## Livestock Plaza/Sheep Barn

Addendum Issue Date: 8/12/24

**C5.1**

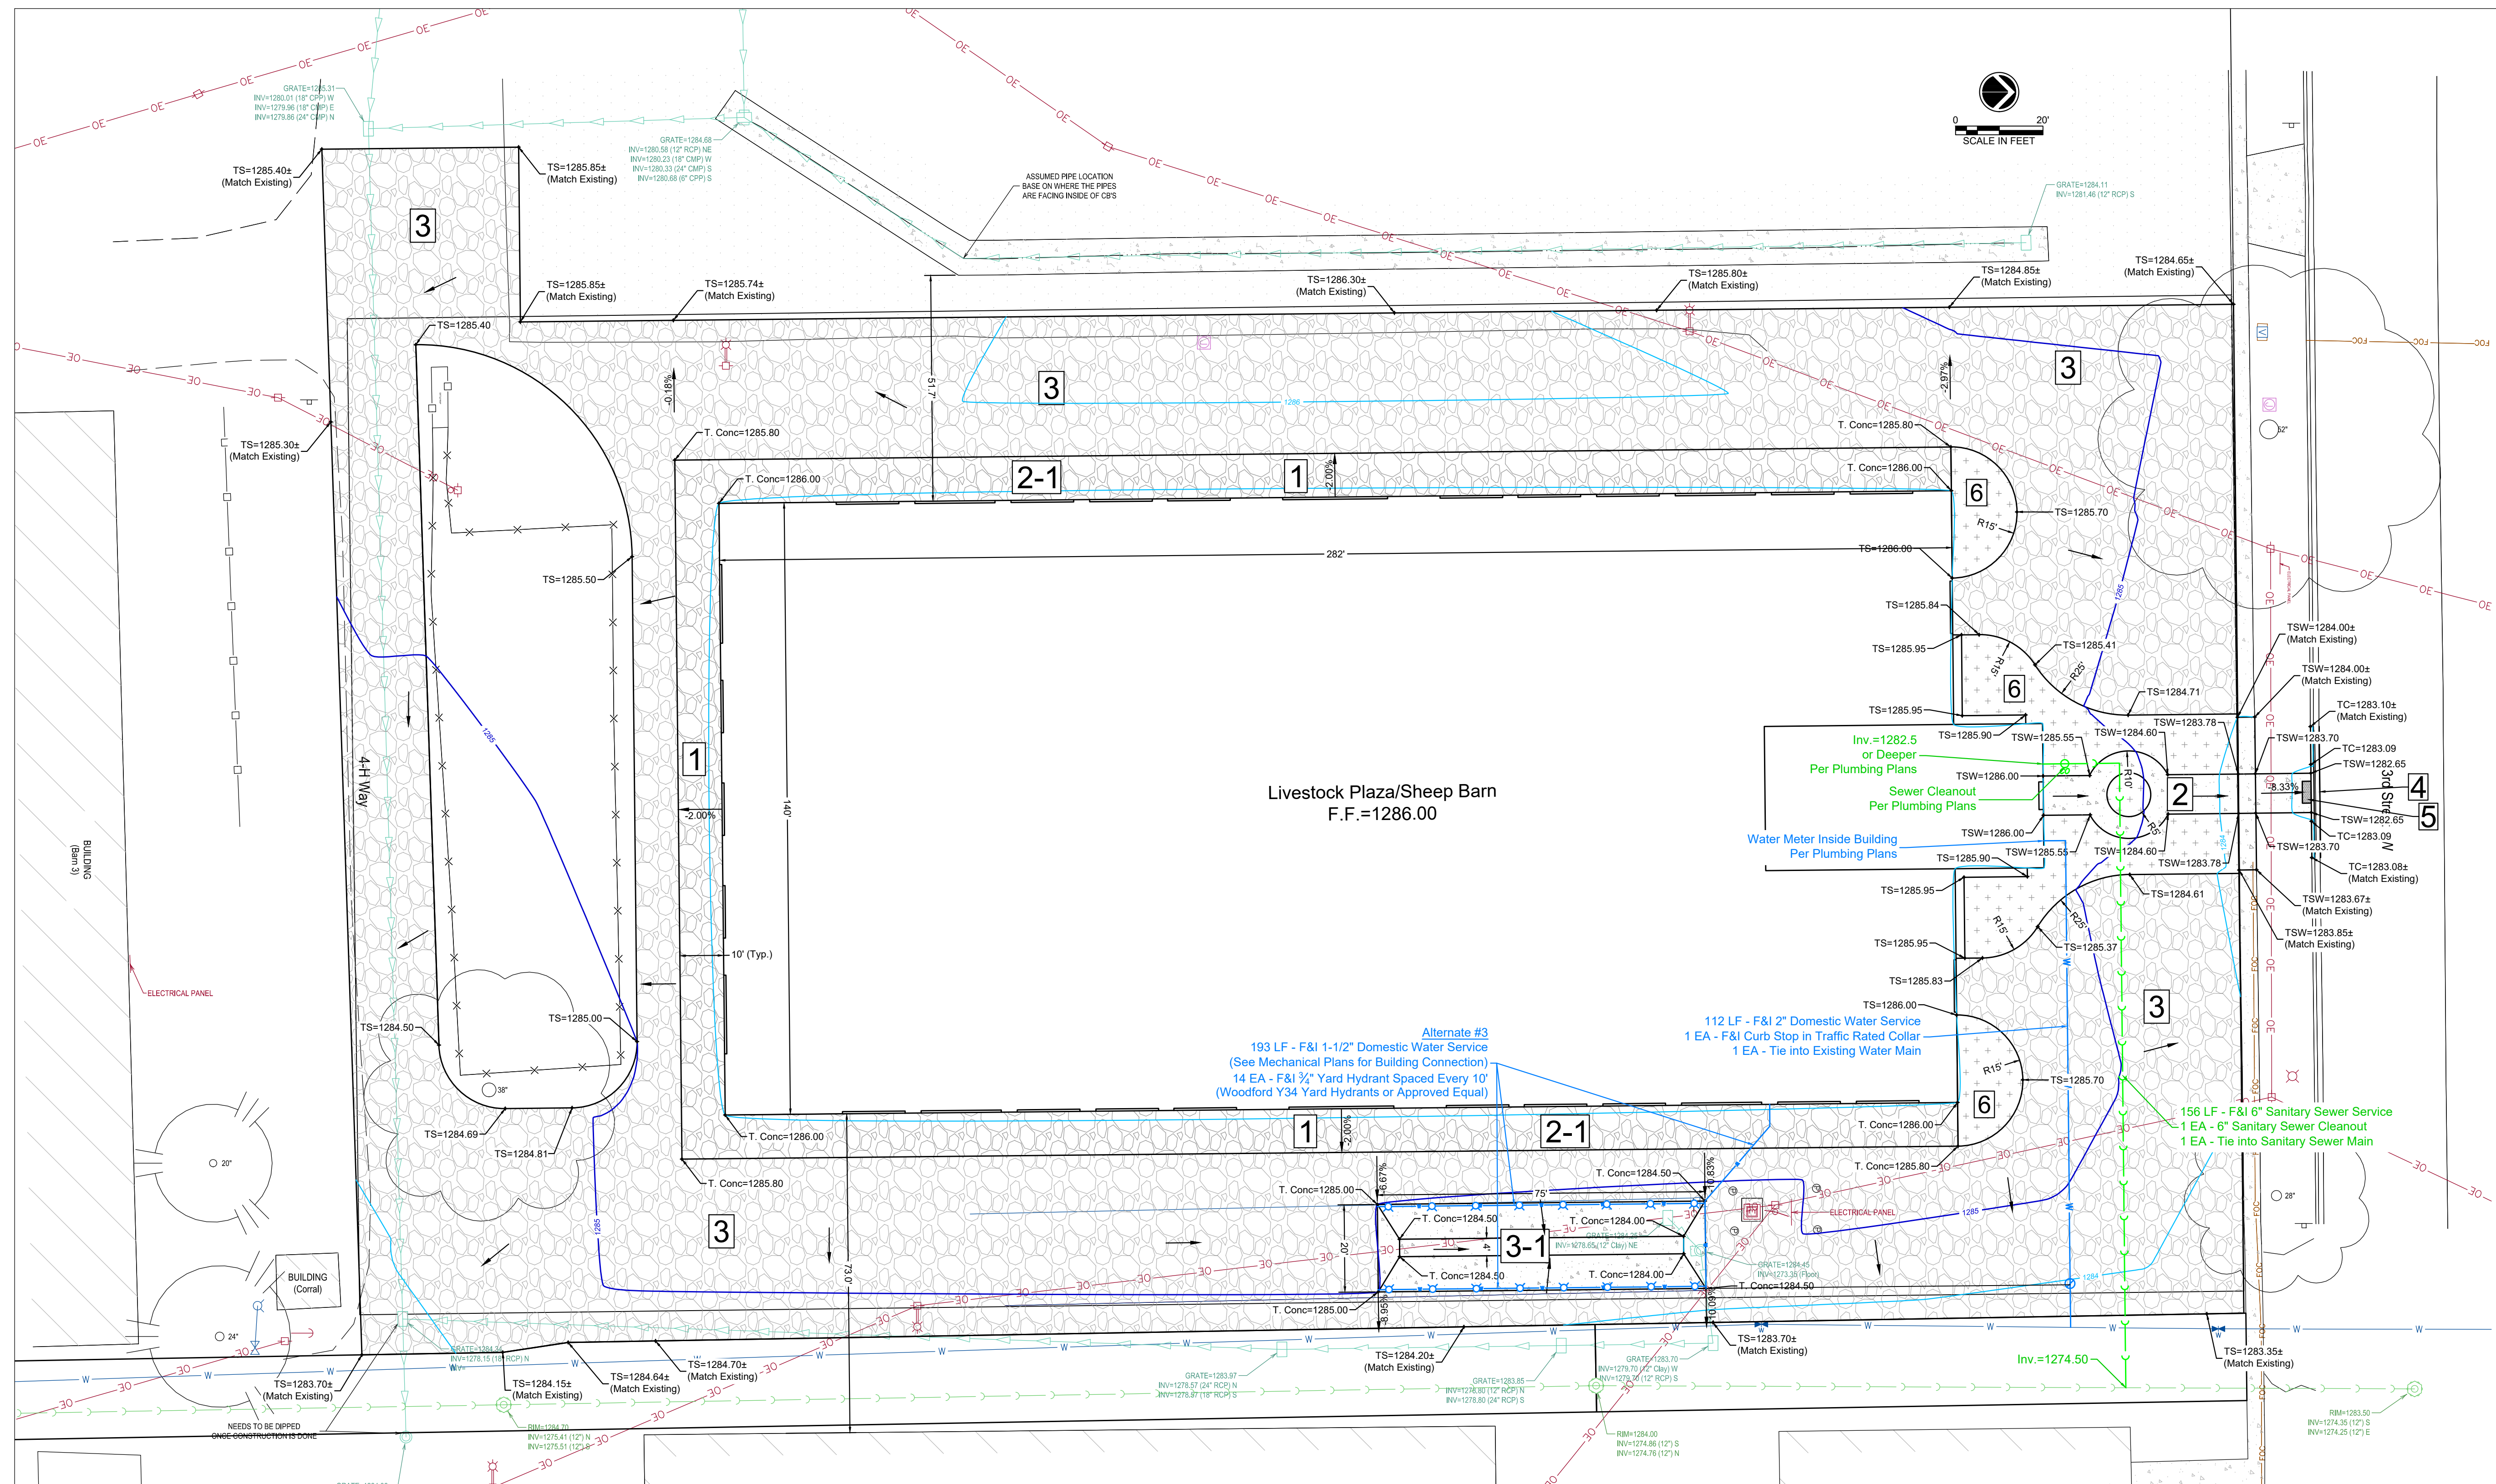
**C5.1 - Site Grading & Utilities**

- Wash rack water line revision.

SHEET:  
**S1.1**

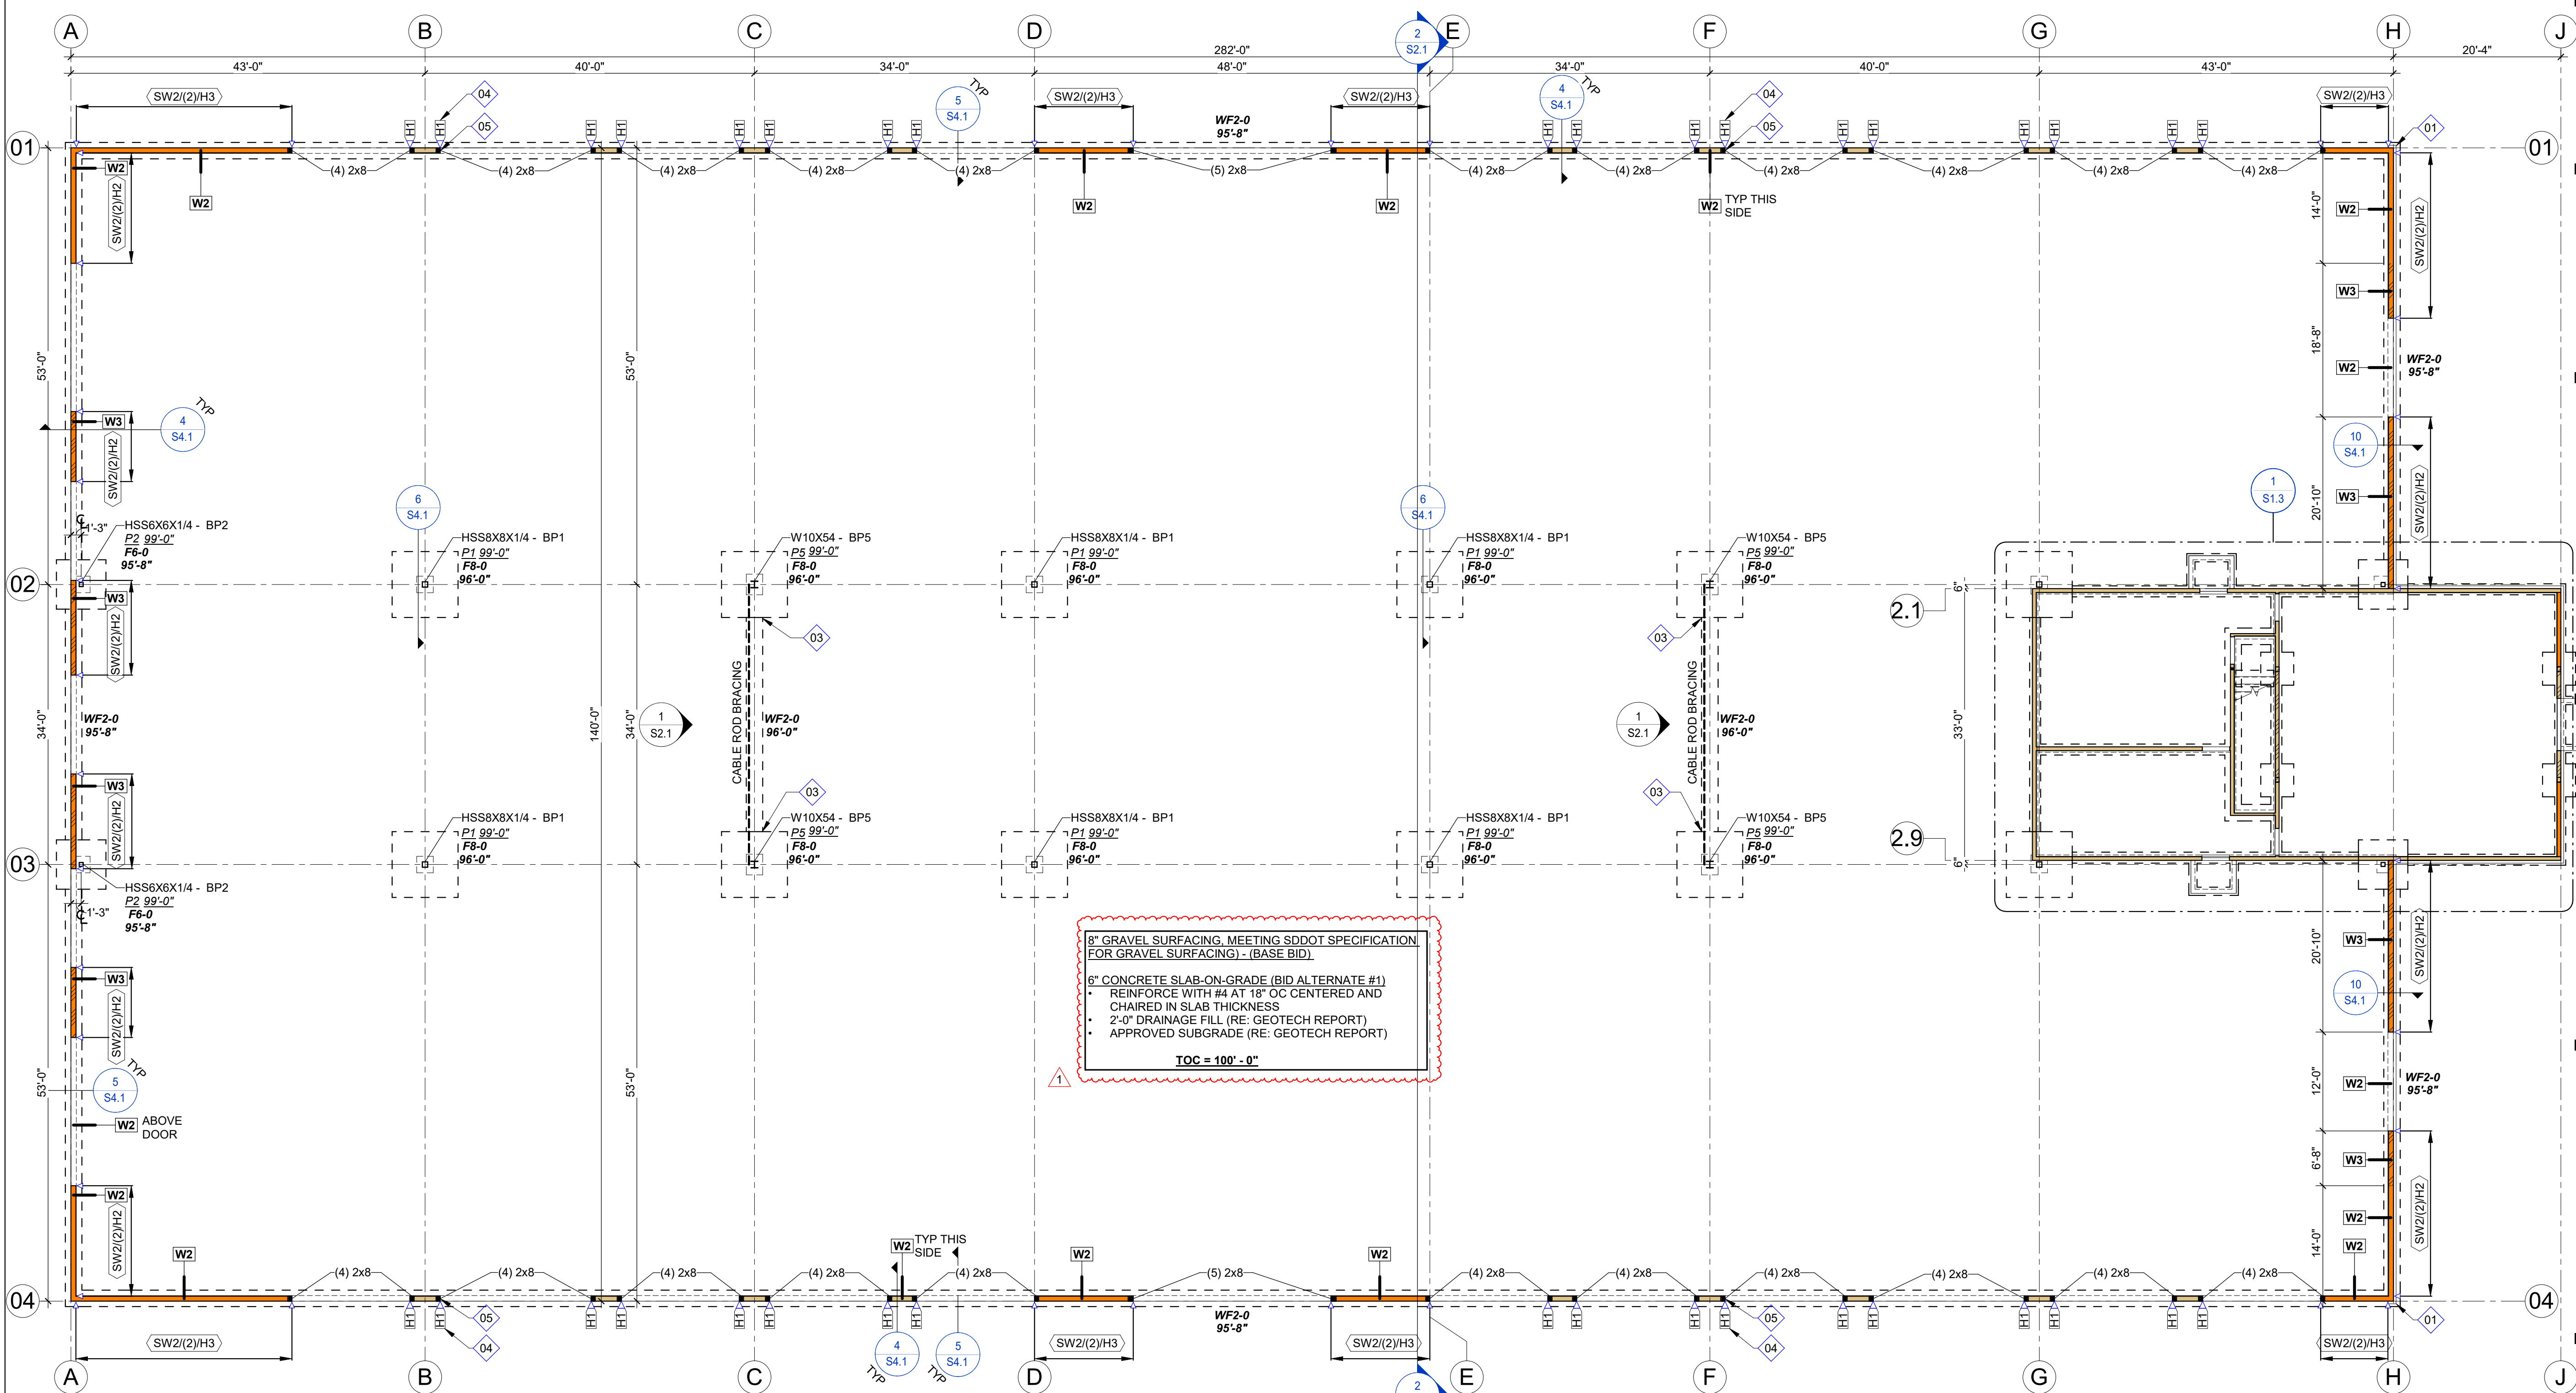
**S1.1 – Main Level Plan**

- Gravel surfacing addressed.

**A4.1**

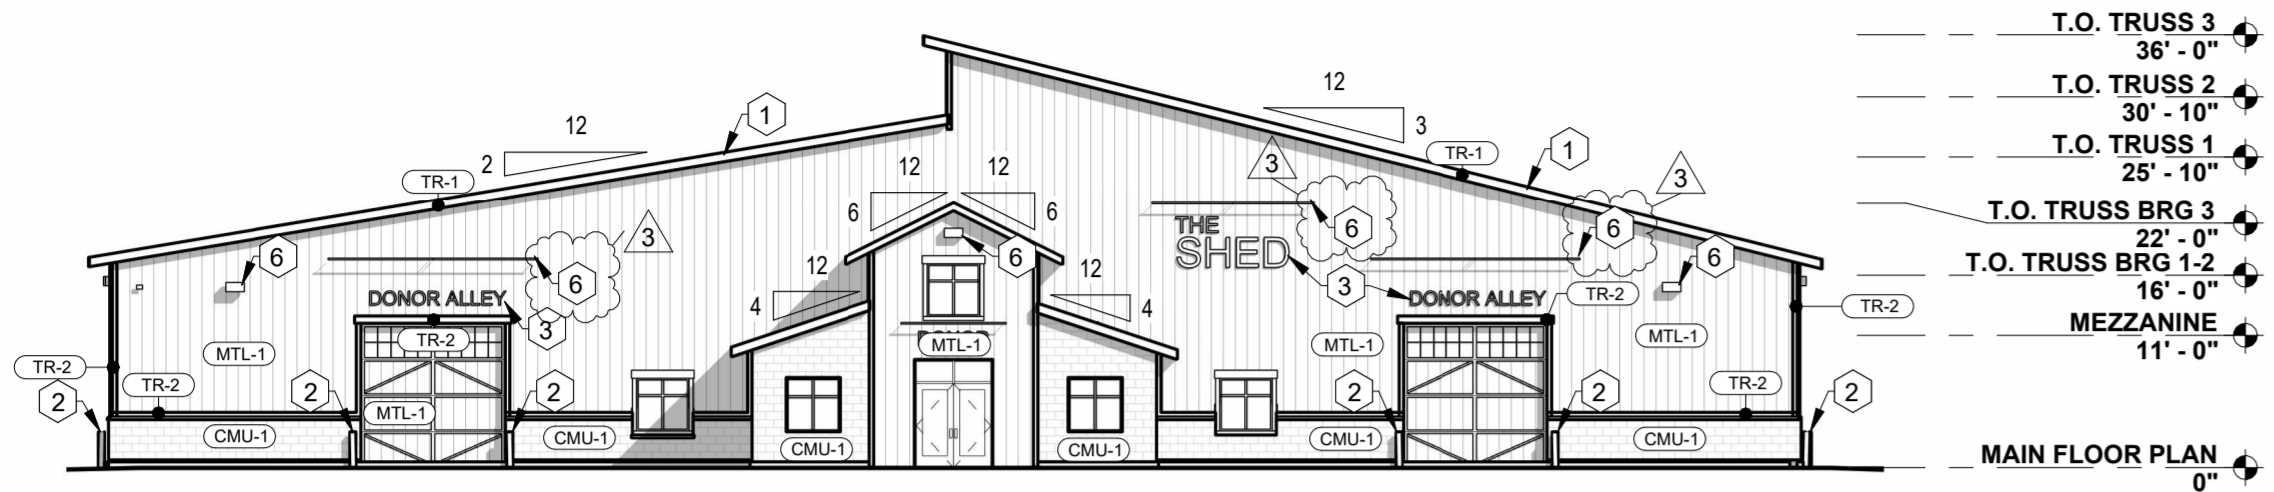
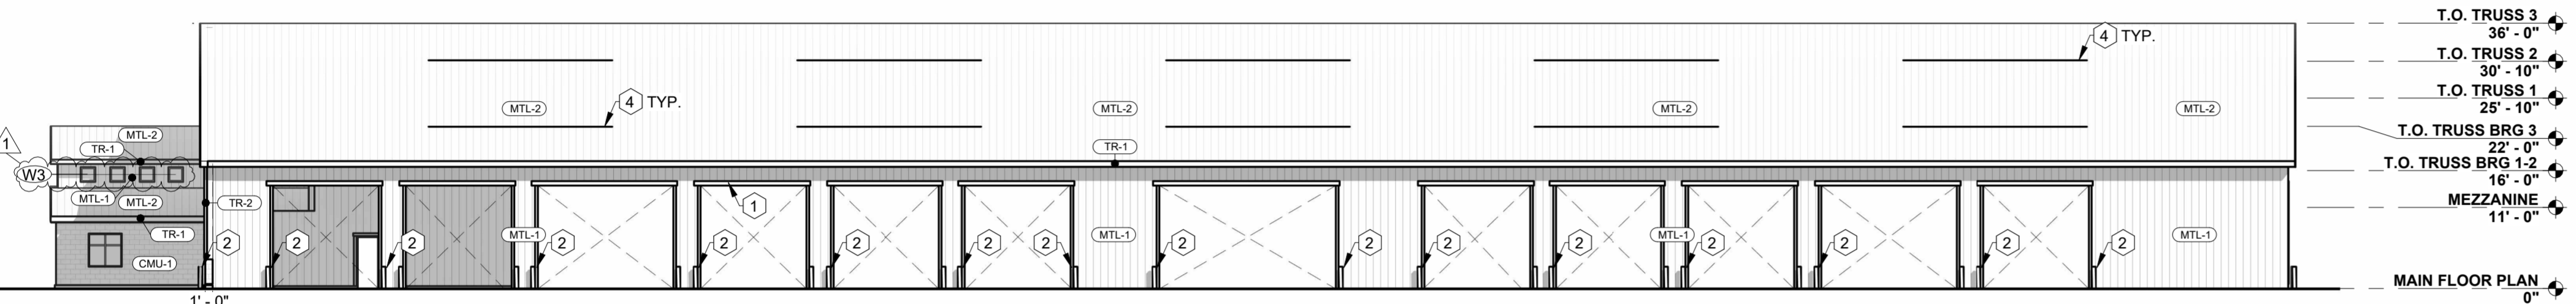
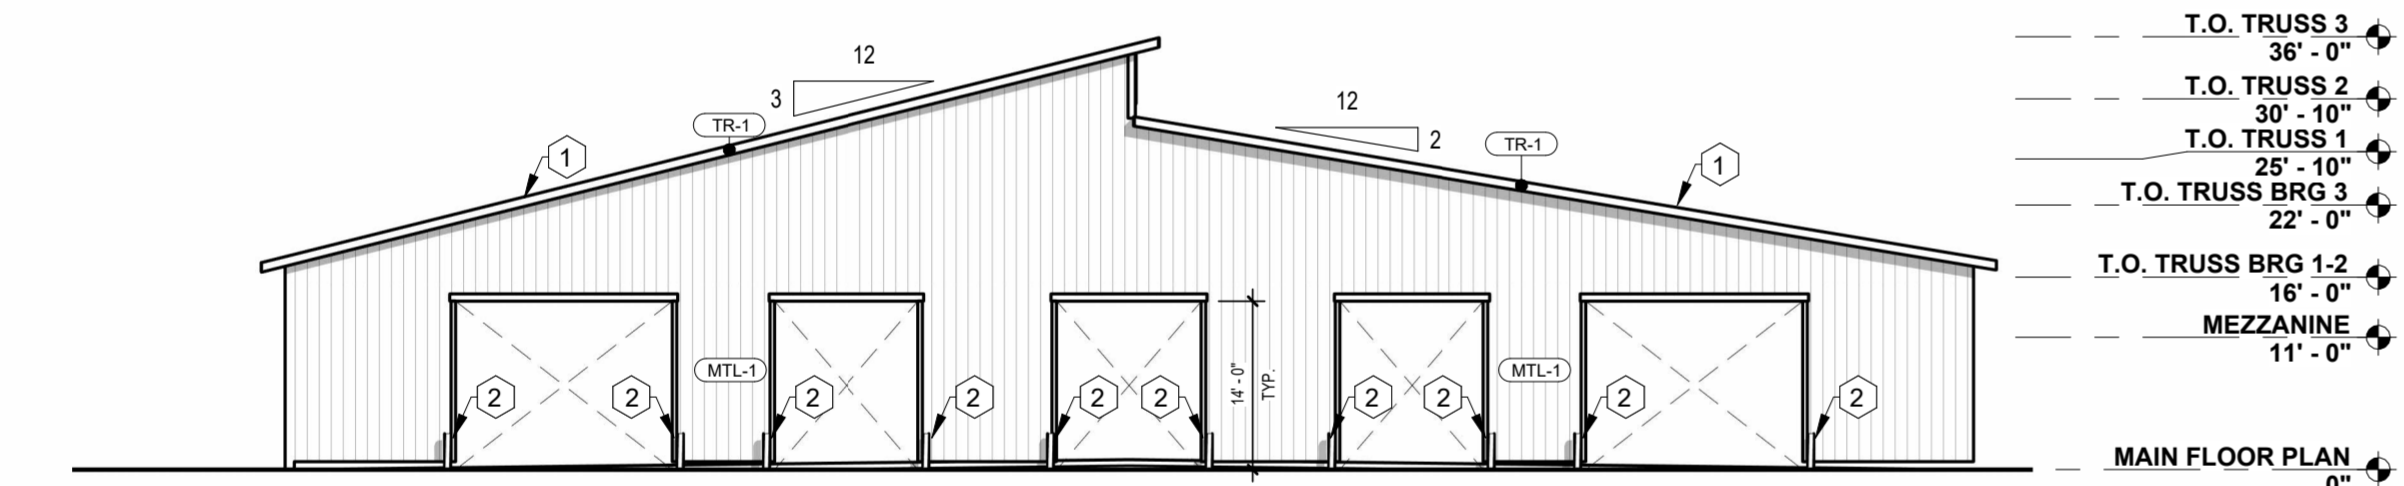
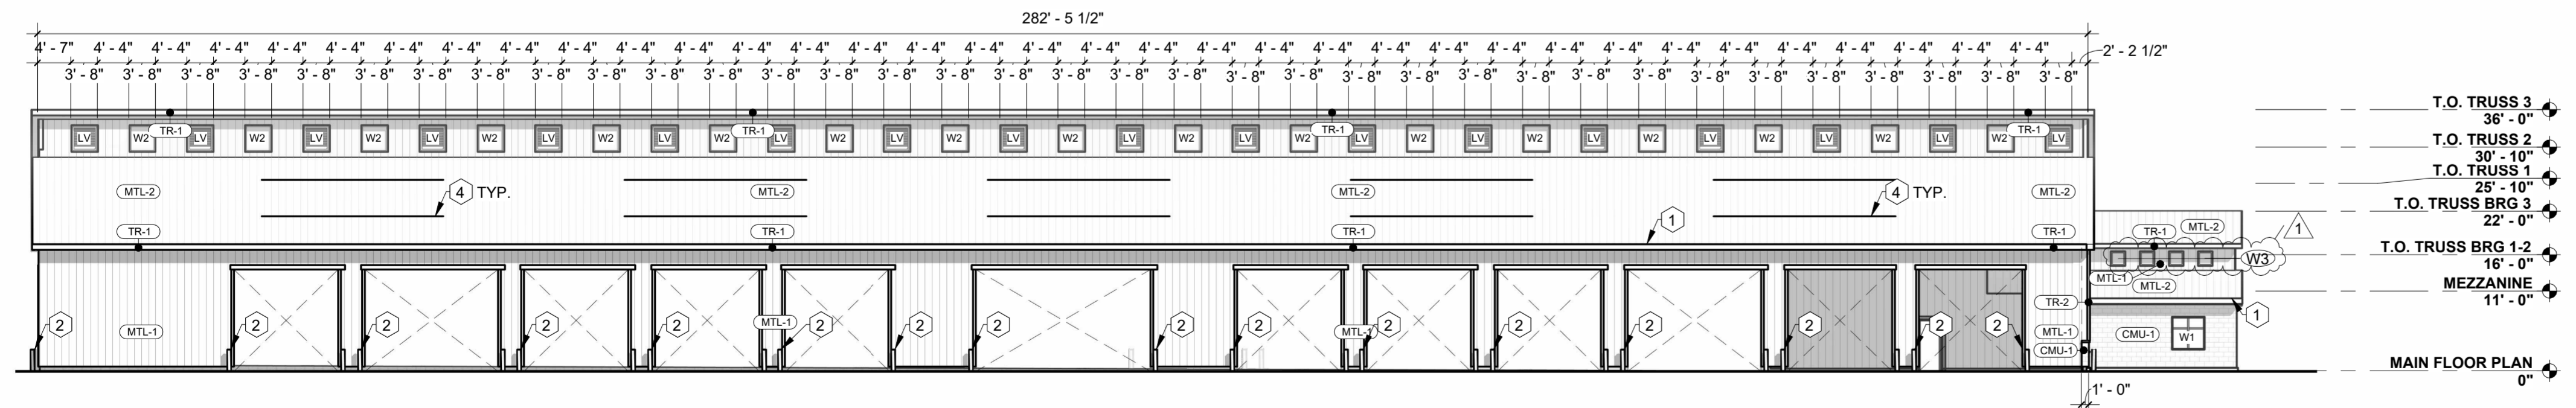
**Sheet A4.1 - Building Elevations:**

Keynotes 5 revised.
